Video8

B-mechanism know-how

8 MECHANISM DECK

Contents

Tape not wound (Deformation of gooseneck retainer)-1

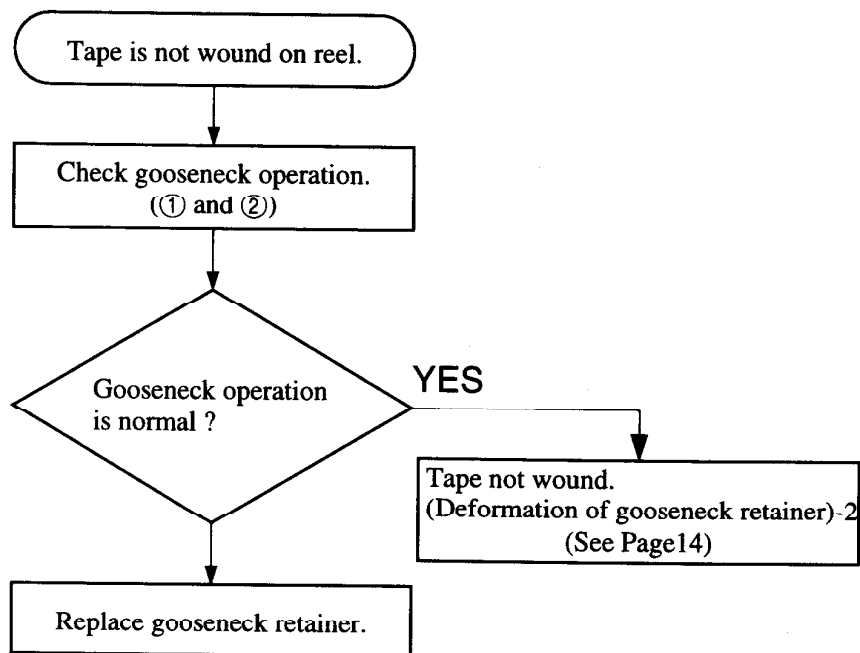
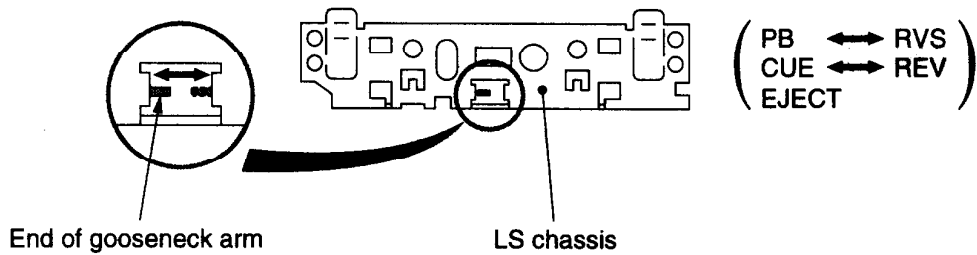
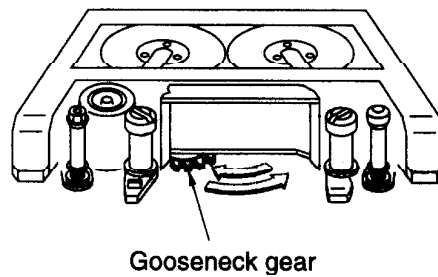
A. Gooseneck gear ass'y is not operating due to deformation of gooseneck retainer. Tape is not wound on reel table.

Gooseneck gear ass'y touches the gooseneck retainer due to warp of the retainer, so gooseneck gear does not operate properly and is not meshed with the gear of reel table.

Mounting screw No.2 3-976-055-01
Gooseneck retainer (2) 3-989-479-01

- ① When LS is completed, check the operation of gooseneck gear ass'y from the hole at front of LS chassis.

- When the end of gooseneck arm is at extreme left, it is meshed with T reel table.
- When the end of gooseneck arm is at extreme right, it is meshed with S reel table.

Tape not wound (Deformation of gooseneck retainer)-2

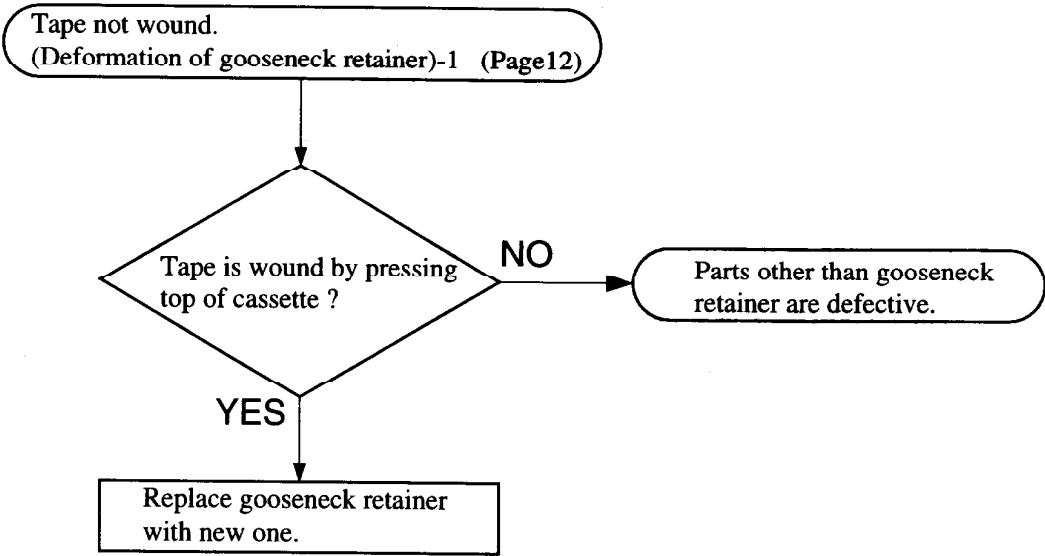
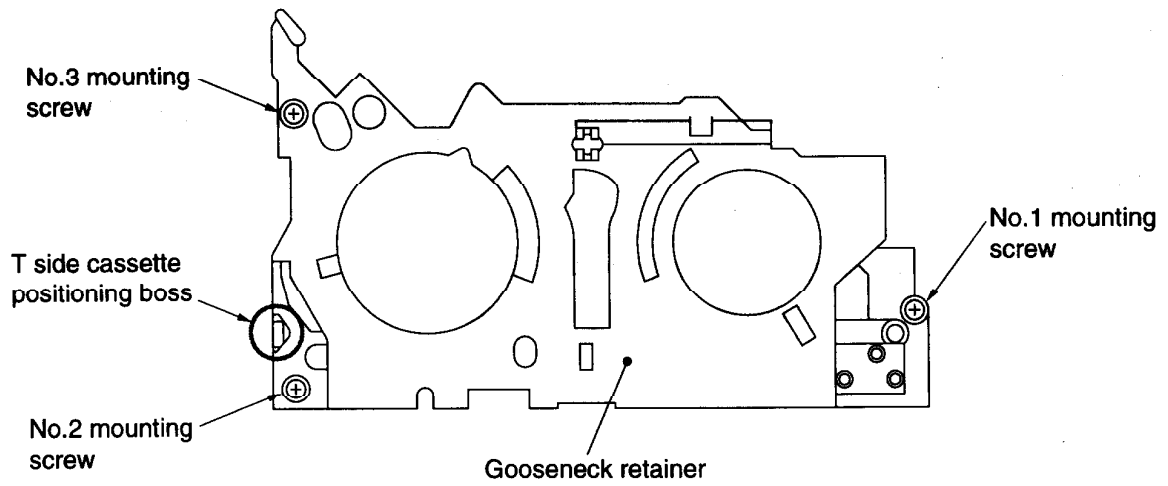
B. Gooseneck retainer is warped or deformed. Cassette is not set in place and tape is not wound on reel.

Gooseneck retainer is warped (center top) or deformed (inclination of T side cassette positioning boss (see diagram at page15)), so cassette is not set in place. Reel hub in cassette touches cassette shell and tape is not wound on reel.

Former parts		New parts
Part No.	3-965-584-01	➔	3-965-584-08
Shape of T side cassette positioning boss	 		 
No.2 mounting screw	3-947-503-01 M1.4 x 2.5	➔	3-976-055-04 Shoulder screw, M1.4 x 1

2**Tape not wound (Inclination of TG4)**0000000 E.014
W0102**(Symptom)**

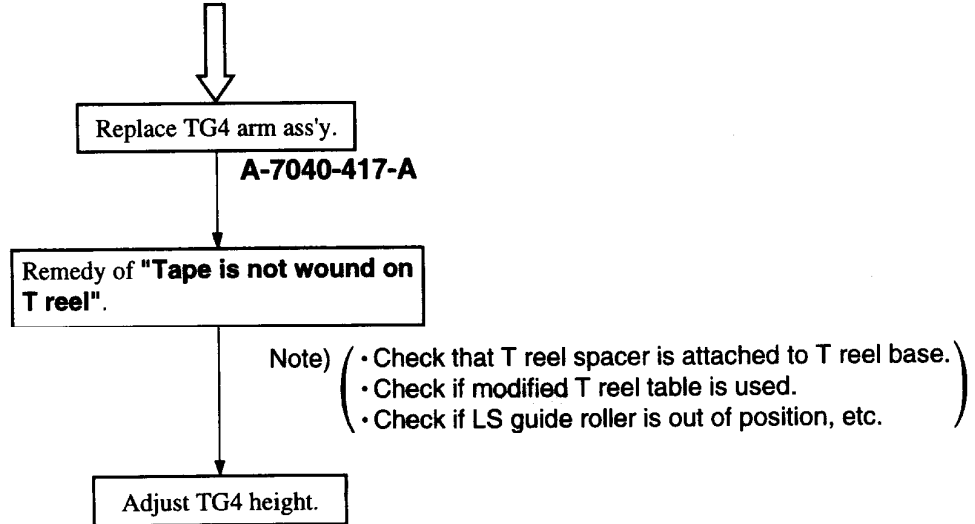
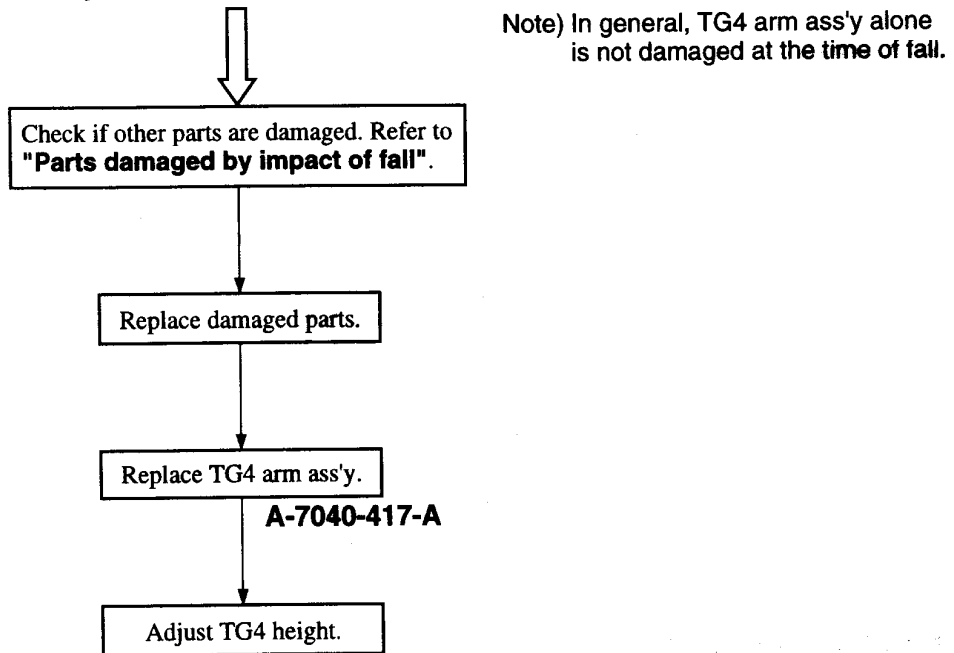
TG4 is bent, causing tape jamming (irregular tape travel) and loading/unloading failure (TG4 shaft is inclined from the groove of mechanism chassis).

1. Cassette of jamming tape was removed forcibly when the tape was caught in TG4.
2. The set was dropped off during unloading operation, and TG4 was separated from the groove of mechanism chassis.
3. LS chassis was pushed forcibly at the time of tape top processing.

Change the material of TG4 arm.

3**No eject (Trouble with M slider at unloading)****(Symptom)**

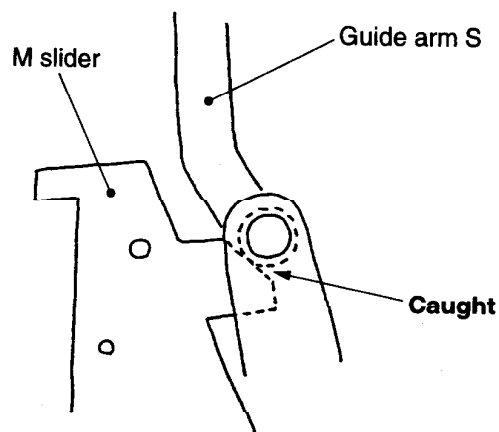
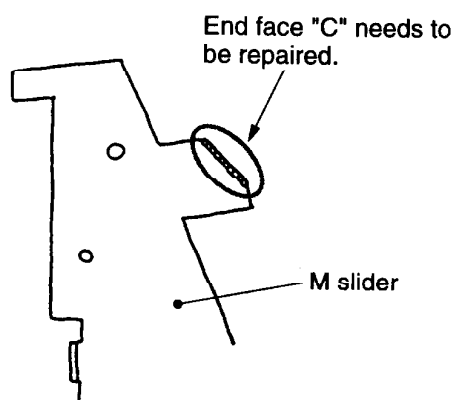
The caulked portion of guide arm S is caught in the edge on the end face of M slider, causing unloading failure.

The end face "C" of M slider is small and the caulked portion of guide arm S was caught in the end face.

Repair M slider end face "C".

Replace M slider.

4**Video recording guide tape cassette not winding properly.****(Symptom)**

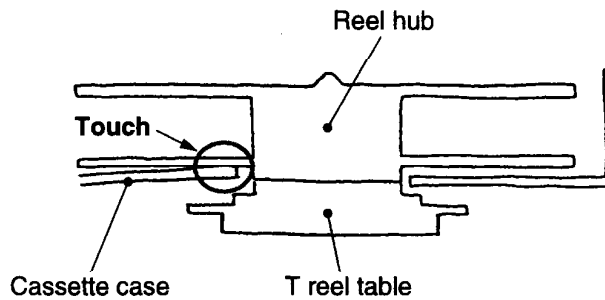
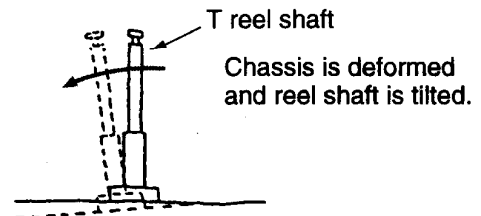
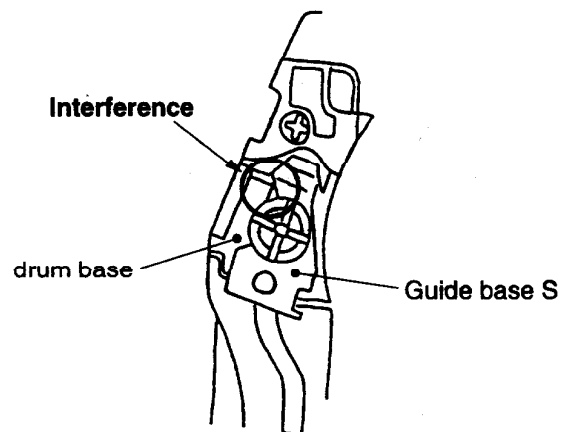
Reel hub touches the bottom of the case of video recording guide tape cassette, and tape cannot be wound due to failure of reel rotation.

1. Flatness of video recording guide tape cassette is NG.
2. The height of T reel is low due to deformation of chassis at cassette compartment DOWN with the spring force of cassette compartment, causing a fall of T reel shaft.

1. Change the verticality tolerance of T reel shaft.
2. Correct the flatness of video recording guide tape cassette.
3. Change the height of T reel (spacer can be used temporarily).

- Replace video recording guide tape cassette.
- Check T reel shaft for bending.

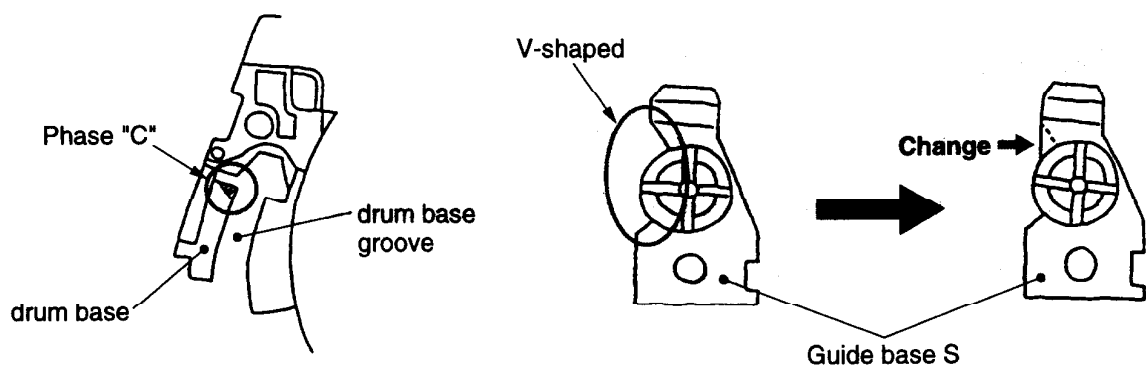
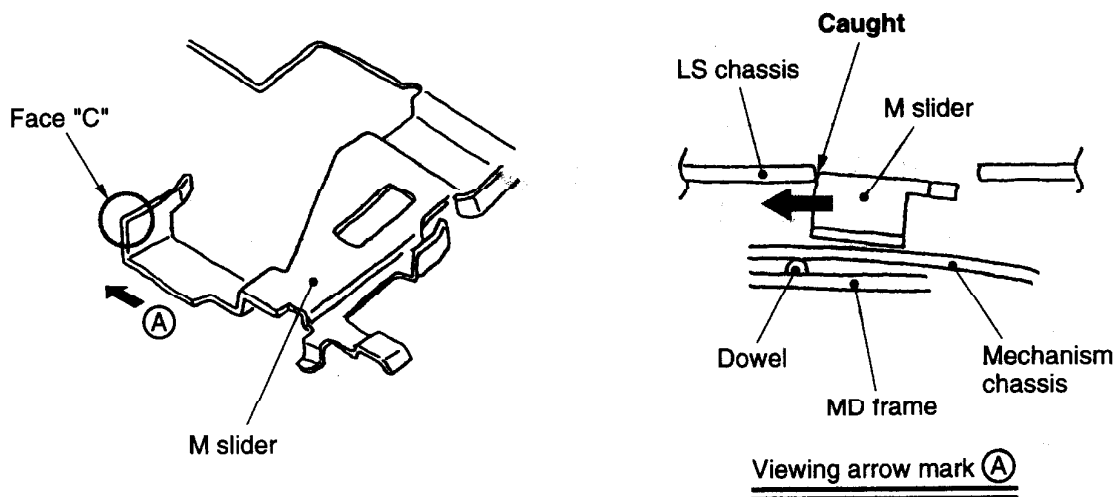
The corner of drum base groove is caught in the V-shaped guide base S at unloading, causing unloading failure.

Interference due to variations of the corner of drum base groove and the shape of edge of guide base S (insufficient margin).

1. Repair the corner "C" at entrance of drum base groove.
2. Change the V-shaped side of drum base to straight type.

- Replace guide base S ass'y.
- Replace drum base ass'y.

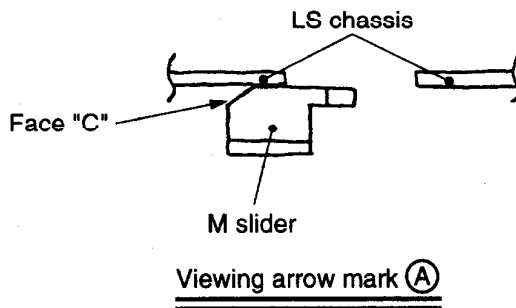
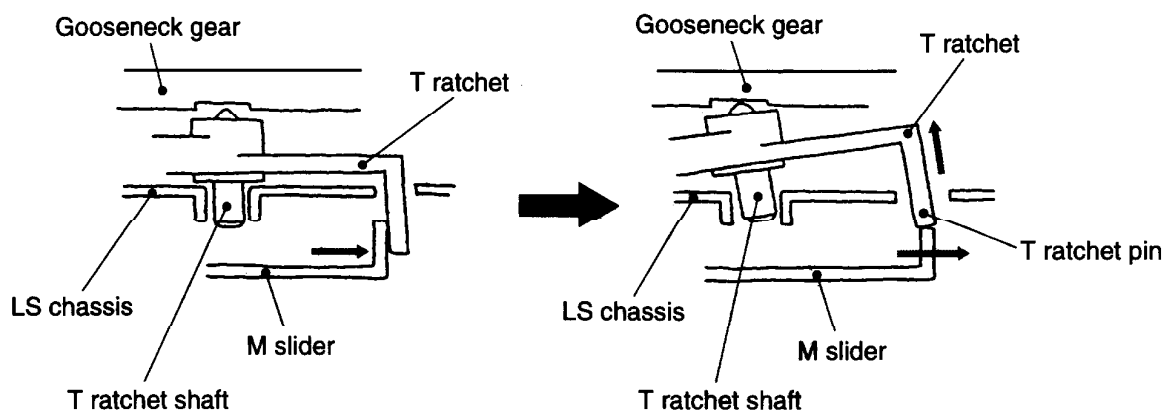
The corner of M slider is caught in the hole of LS chassis, causing deformation of M slider and loading failure.

MD frame was mounted when the dowel was floating. The posture of M slider was changed due to warp of mechanism chassis, and the corner of M slider entered the hole of LS chassis.

Repair the corner "C face" of M slider to prevent it from being caught.

Replace M slider ass'y.

7**No unloading (T ratchet pin riding over M slider)****(Symptom)**

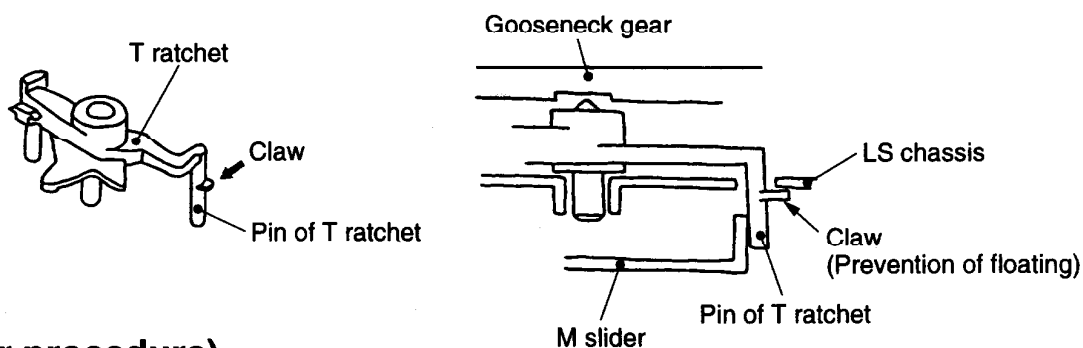
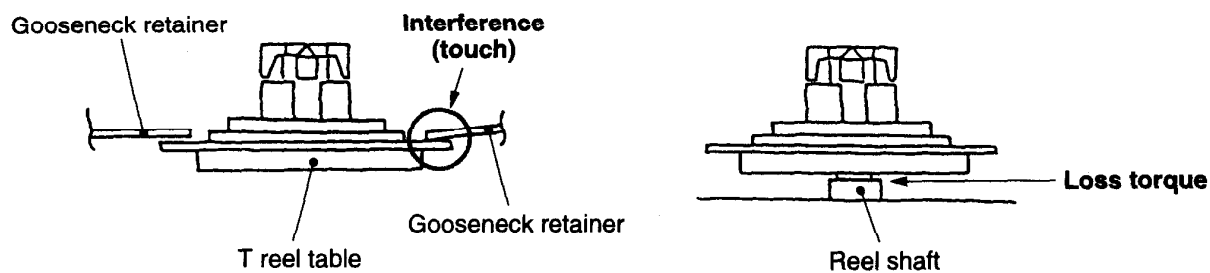
T ratchet pin rides over M slider and is caught at loading/unloading, causing failure of resetting T ratchet.

T ratchet shaft is loosened in the hole of LS chassis, and M slider is pushed to M slider at change of mode, so T ratchet is tilted. The pin rides over the wall of M slider and cannot be reset.

1. Turn T reel with hand and check that it is meshed with reel table. (Factory check)
2. Pad the foot of T ratchet to prevent tilting.
3. Add a claw to the pin of T ratchet and hook on LS chassis to prevent T ratchet from floating.

Replace T ratchet.

(Former)
3-965-581-01

(New)
3-965-581-03

8**Tape not wound (Causing tape slack and T reel caution)****(Symptom)**

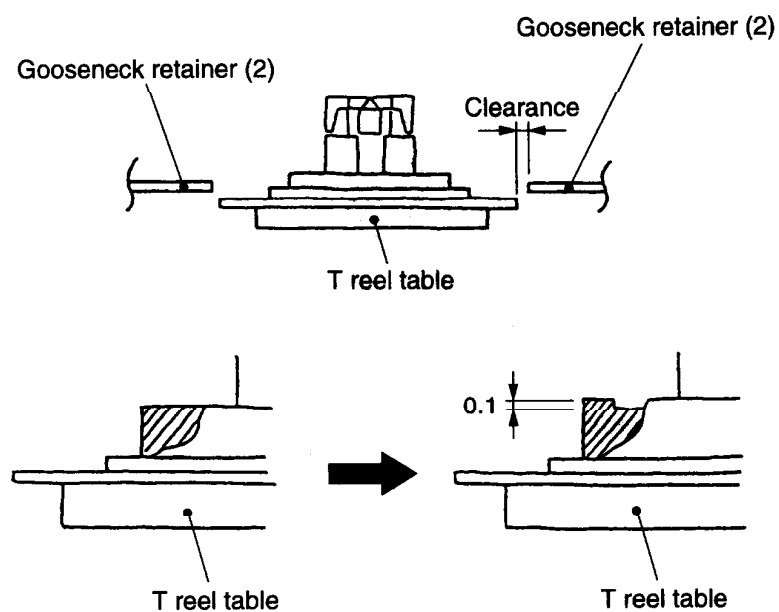
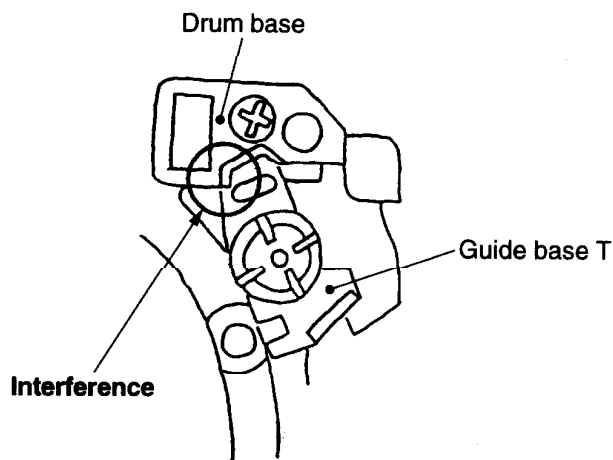
Tape is not wound on T reel at PB mode, causing tape slack and T reel caution.

1. The outer surface of T reel touches gooseneck retainer due to deformation of gooseneck retainer (no clearance in the direction of height).
2. The margin of T reel height is insufficient (the height of reel table is low).
3. Loss torque between reel table and reel shaft is large, reducing FWD winding torque.

1. Change the size of T reel hole for gooseneck retainer (prevention of interference).
Gooseneck retainer (2)
2. T reel table height +0.1 UP
3. Apply oil to reel shaft and change the material.
4. Check FWD winding torque.
Former type Without check and standards
After change FWD torque 4g·cm or more

1. Move T reel up and down and check that it is not loosened (gooseneck retainer touches T reel table), and change gooseneck retainer with gooseneck retainer (2).
2. When winding torque is small (less than 4g·cm), apply oil to T reel shaft.
3. If it is not corrected by 1 and 2, replace T reel table.
4. If it is not corrected by 1-4, replace LS chassis (reel shaft may be tilted).

9**Threading not completed (Change V-shaped drum base)****(Symptom)**

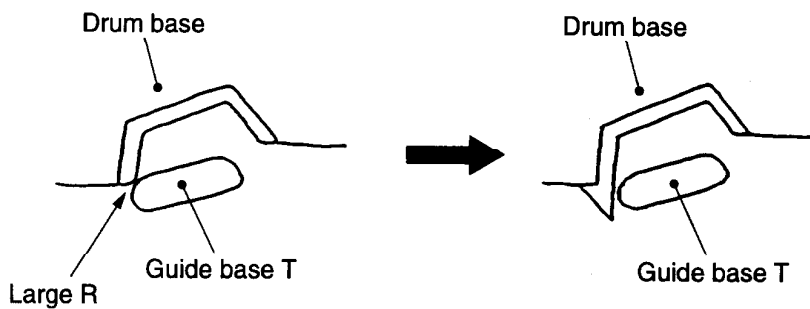
The drum base touches the guide base T at loading, causing failure of tape threading.

The drum base touches the guide base T at the position marked "O".

Extend the V-shaped portion at the corner of V-shaped drum base.

Replace drum base ass'y.

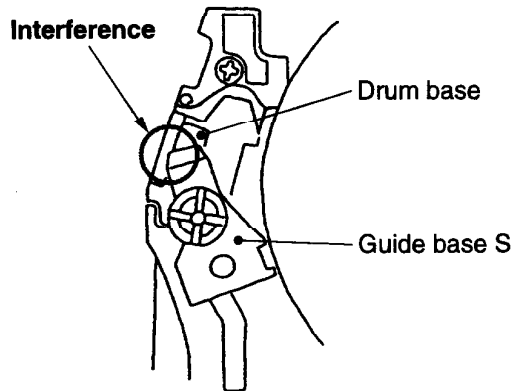
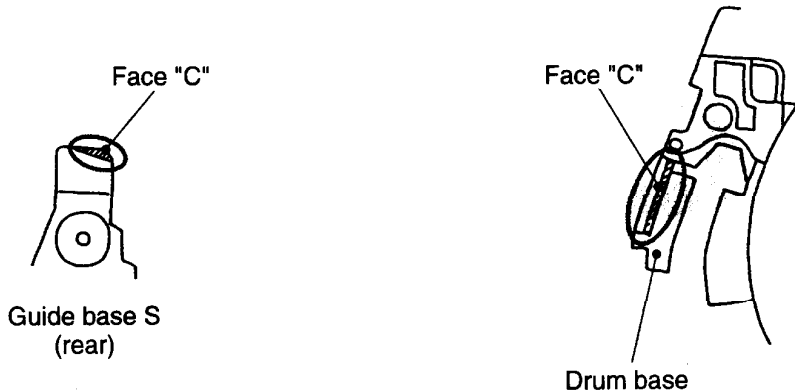
Tip of guide base S is caught in the triangle rib at the entrance of drum base, causing loading failure.

Tip of guide base S caused interference due to variations of position and thickness of drum base rib (insufficient margin).

1. Add face "C" to the tip of guide base S.

Add face "C" to the entrance triangle rib of drum base.

- Replace guide base S ass'y.
- Replace drum base ass'y.

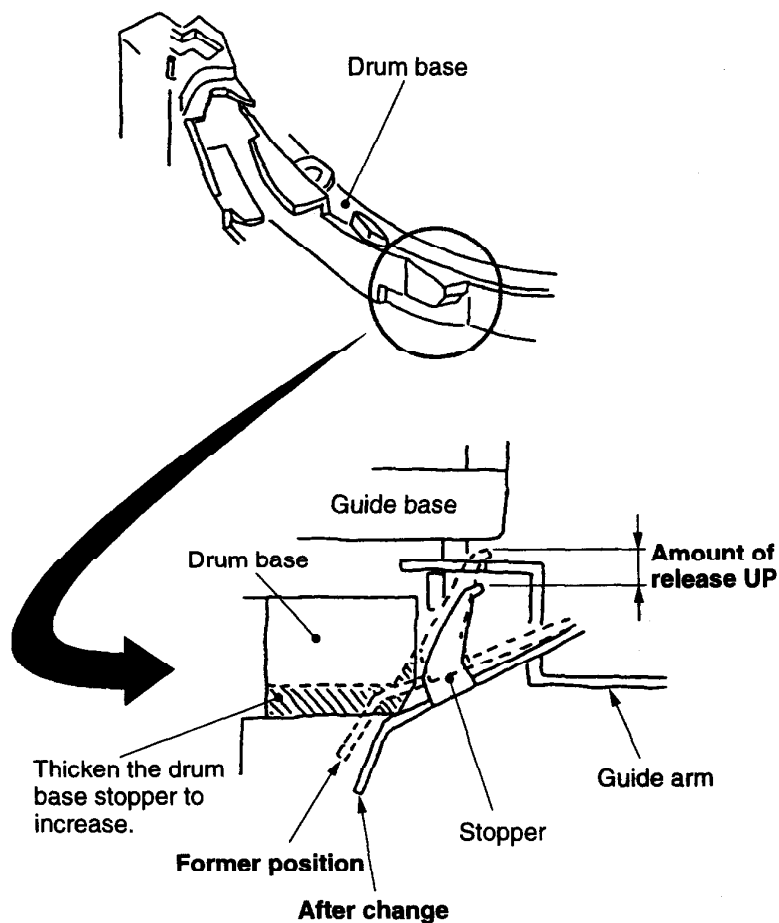
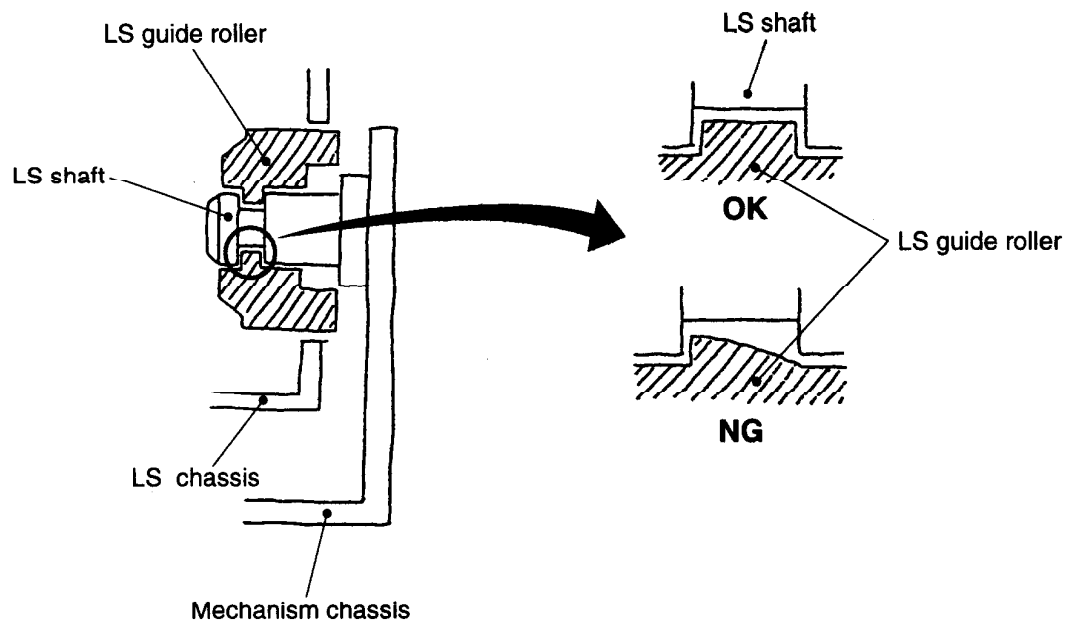
Stopper is not released at guide load, causing loading failure.

Drum base stopper opens at its release position, causing insufficient margin of releasing the claw from the hook of guide arm.

Thicken the drum base stopper to increase the amount of releasing the stopper.

Replace drum base ass'y.

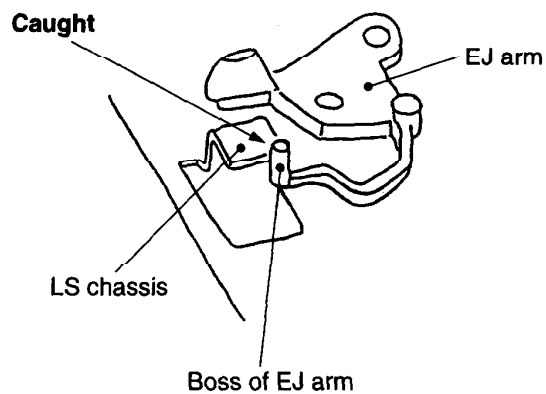
LS guide roller is separated, causing loading /unloading failure. Tape is not wound on reel (cassette gets out of position).

Releasing force of LS guide roller is small due to improper shape of claw that is caught in the groove of LS shaft.

Correct the shape of LS guide roller.

- Replace LS guide roller.
- Do not use the dismantled roller.
